VARIANCE APPLICATION

PROPERTY INFORMATION			
Project/Property Address: Buckles Court North (Lot 2)		Project Name/Business Name: Crescent at Central Park- Lot 2	
Parcel #: 025-013773-00	Zoning: (see Map) SCPD	Acreage: 3.84 acres

CRESCENT AT CENTRAL PARK - LOT 2

Subject: Crescent at Central Park Section 2- Lot 2
City of Gahanna, Franklin County, Ohio
CEC Project 314-902

DRAWING NO. **C200**
SHEET 1 OF 1

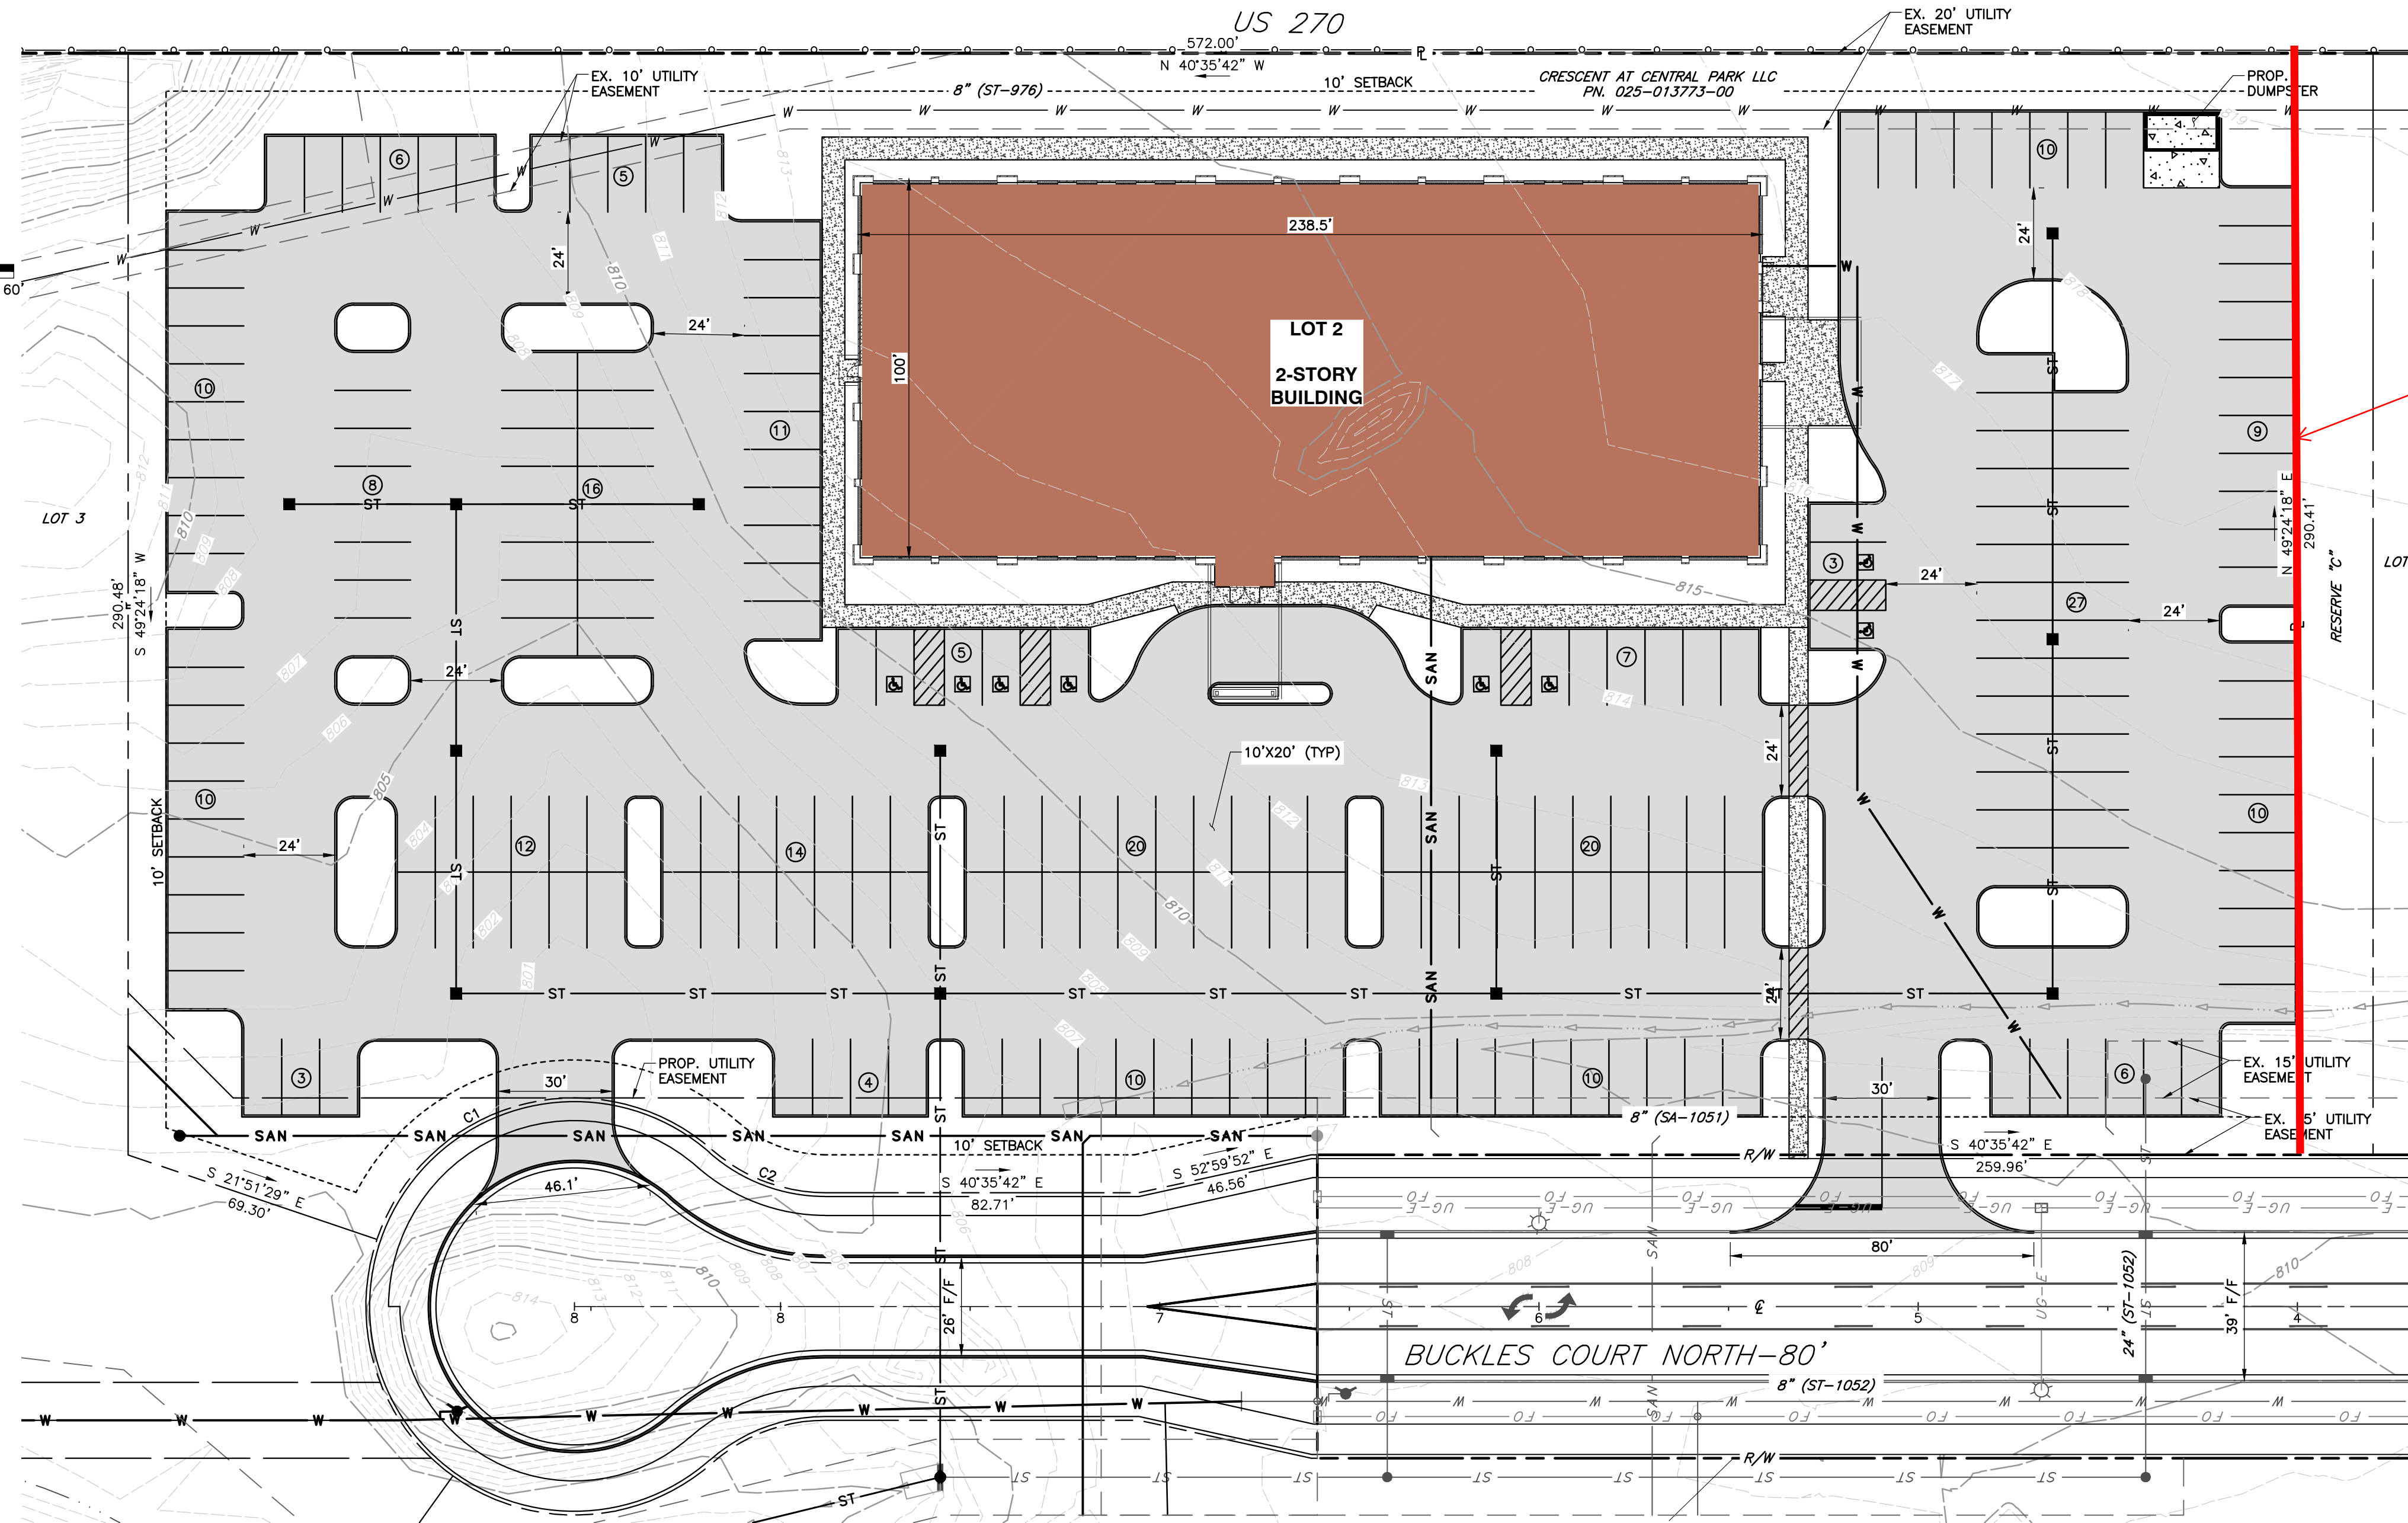
2. Chapter 1163.08(h) requires a ten foot wide tree island between every two rows of parking. A continuous three foot high screen consisting of evergreen plantings is required. The tree island and screening is required in between the two rows of parking. It appears a variance will be necessary as there are areas on the north, south, and west side of the building where there are two rows of parking facing each other. Similar variances have been requested and approved.
Variance request to eliminate the 10ft tree island provided.

3. Chapter 1167.20(b)(7) requires a 15' buffer adjacent to the freeway. The site plan needs to depict the buffer and the landscape plan needs to depict one tree every 30' and a 6' tall continuous hedge, fence, wall or mound.
Variance request to provide the 15' buffer with no screening provided.

3. Parking for medical uses are based on the number of exam rooms and the amount of staff. Please see CH 1163.02(a) for details and please revise accordingly.

4. Please revise the site statistics table to include building height. It appears the proposed two story building will meet code requirements, however the height in feet needs to be included.

5. Chapter 1167.20(b)(7) requires a 15' buffer along the property line adjacent to the freeway. One tree every 30' is required and a 6' continuous hedge, fence, wall or mound is required. Please revise the FDP to depict the 15' buffer. The Design Review application should be revised to depict the location of the buffer and screening.

9. Please revise the application to reflect the construction of a 5-ft wide concrete sidewalk along Lot 2's frontage to Buckles Court North. Construction of this sidewalk to public standards and its subsequent dedication to the City are a condition of this application's approval. (Streetscape)
Sidewalk added to the entire frontage of Lot 2.

Parking data has been revised based on exam rooms and largest shift.

The building height has been added to the site statistics table.

Variance request to provide the 15' buffer but with no screening provided.
